Government of the District of Columbia
Department of Transportation

**Re: Parking Removal at 19th Street NW and T Street NW
NOI #19-24-TOA**

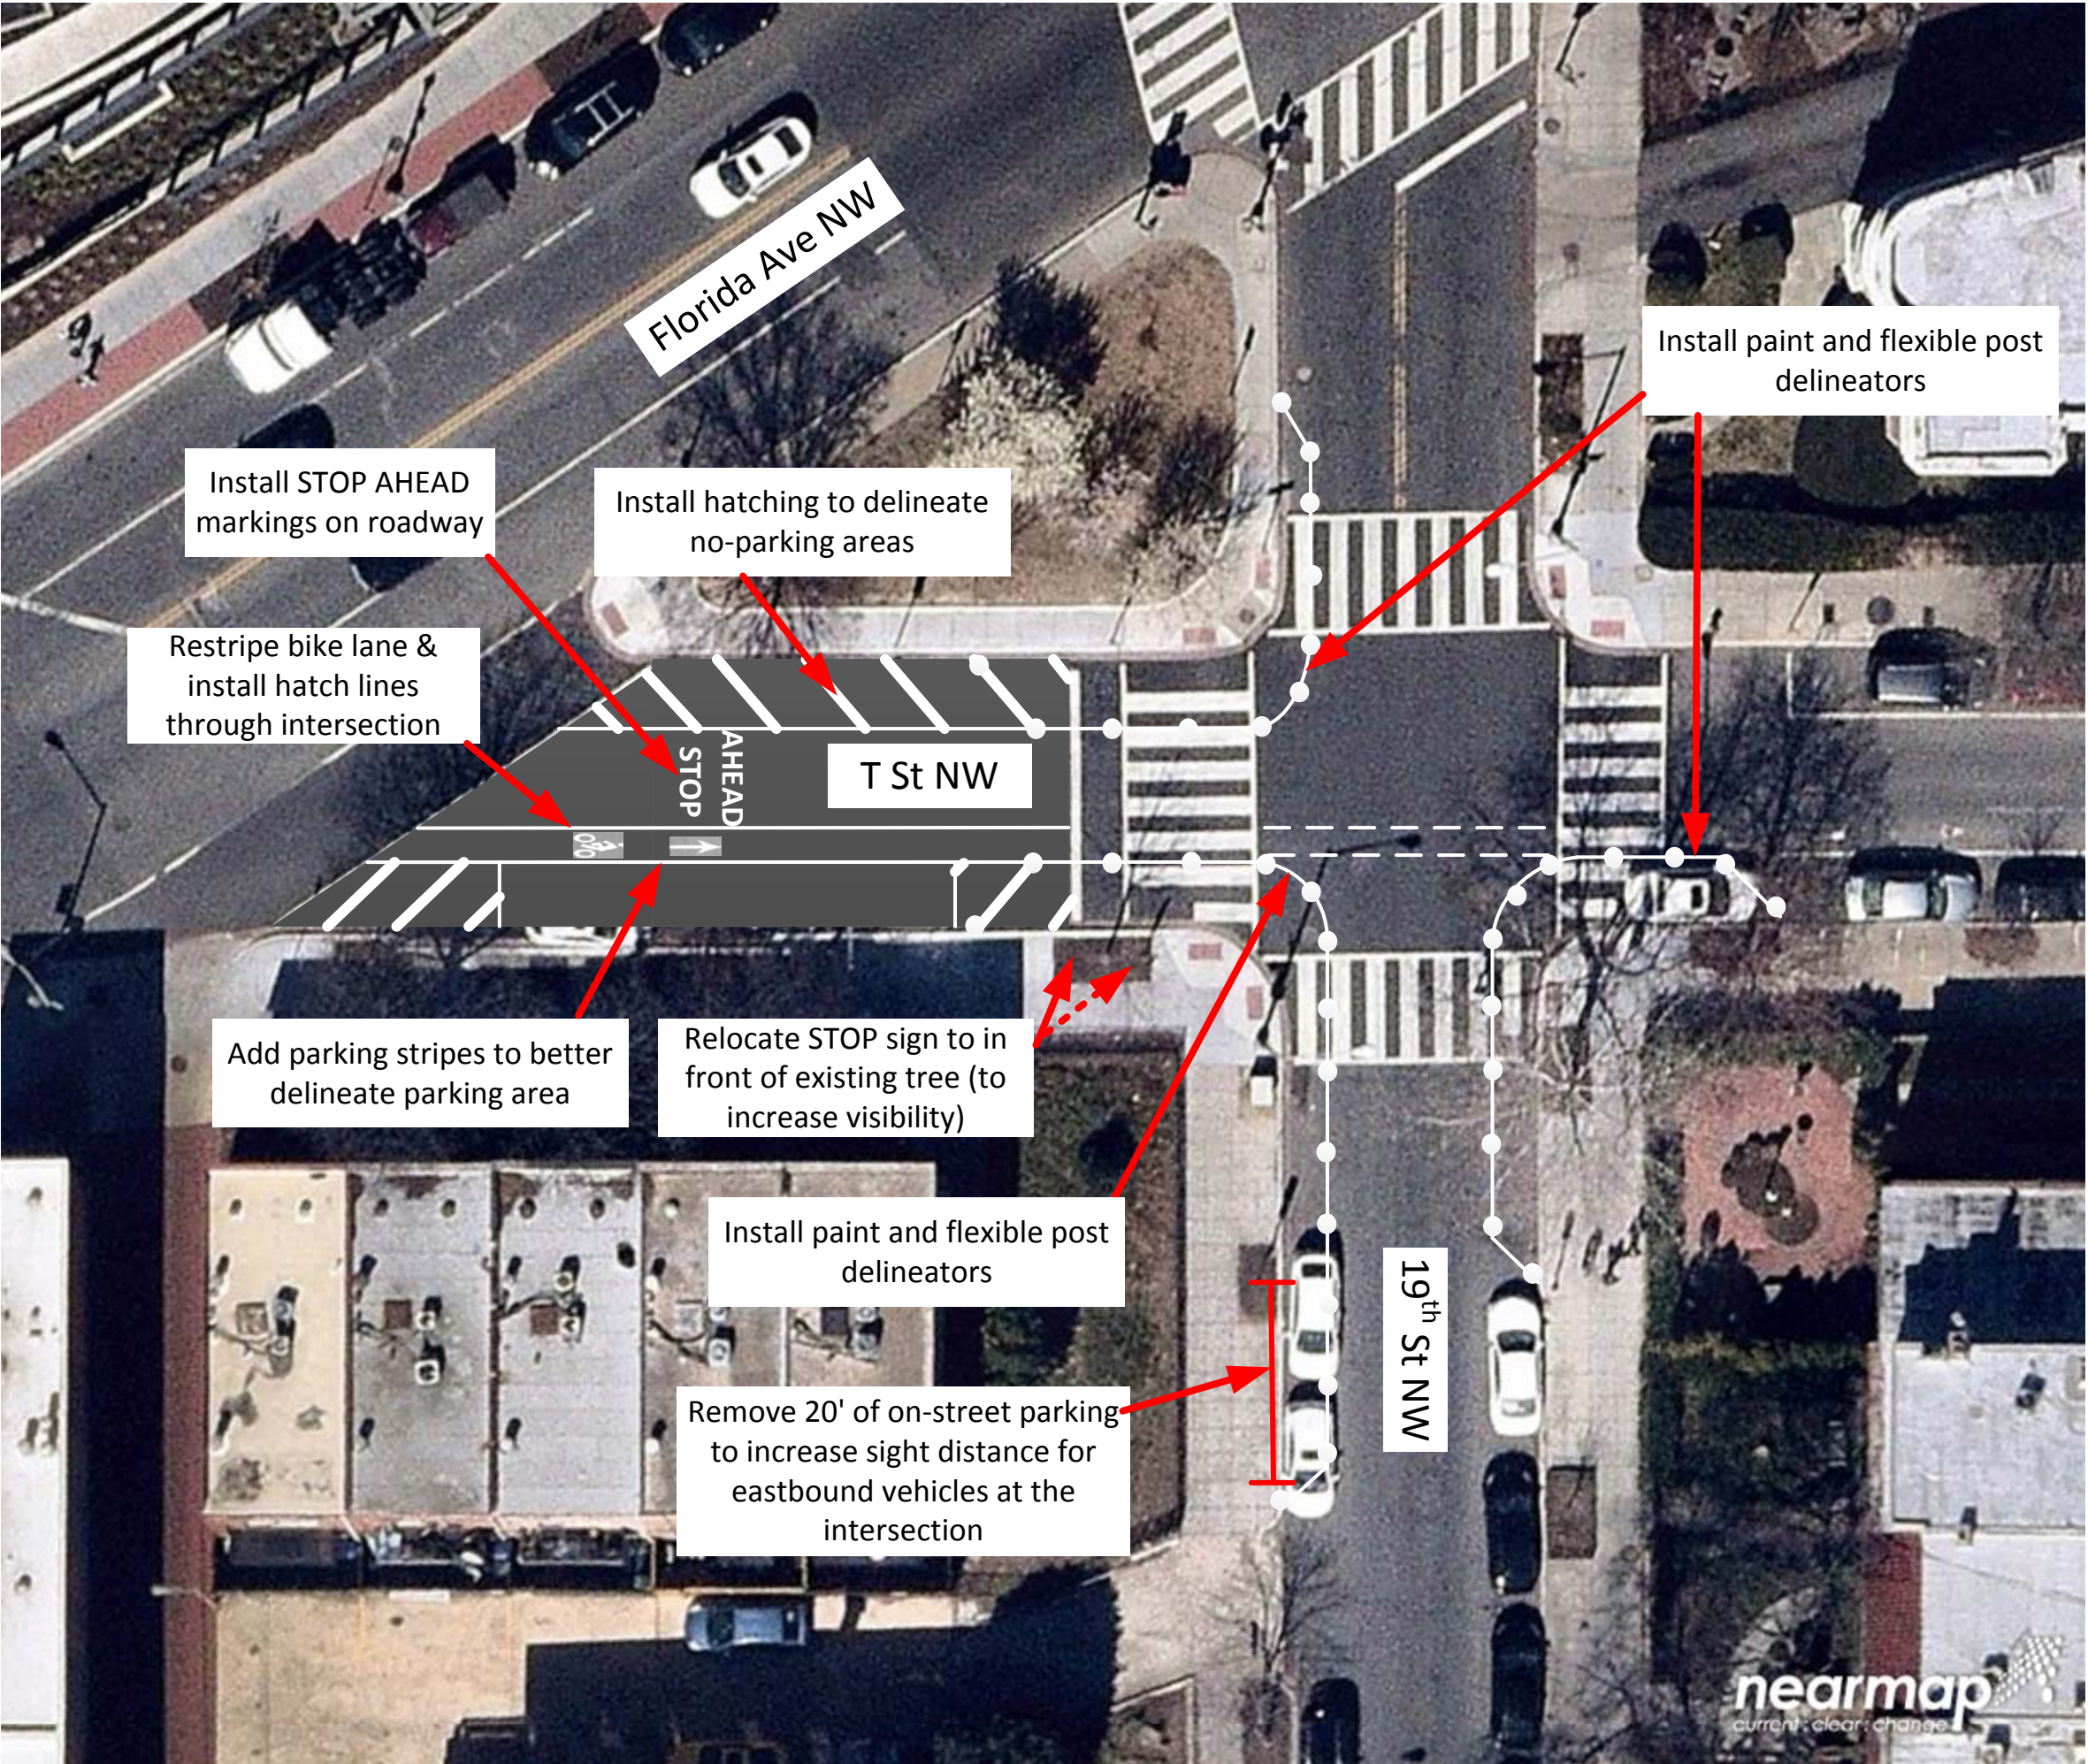
- **Remove 20 feet (1 space) of parking in the southwest corner of 19th Street NW and T Street NW**

Install STOP AHEAD markings on roadway

Install hatching to delineate no-parking areas

Install paint and flexible post delineators

Restripe bike lane & install hatch lines through intersection

Add parking stripes to better delineate parking area

Relocate STOP sign to in front of existing tree (to increase visibility)

Install paint and flexible post delineators

Remove 20' of on-street parking to increase sight distance for eastbound vehicles at the intersection
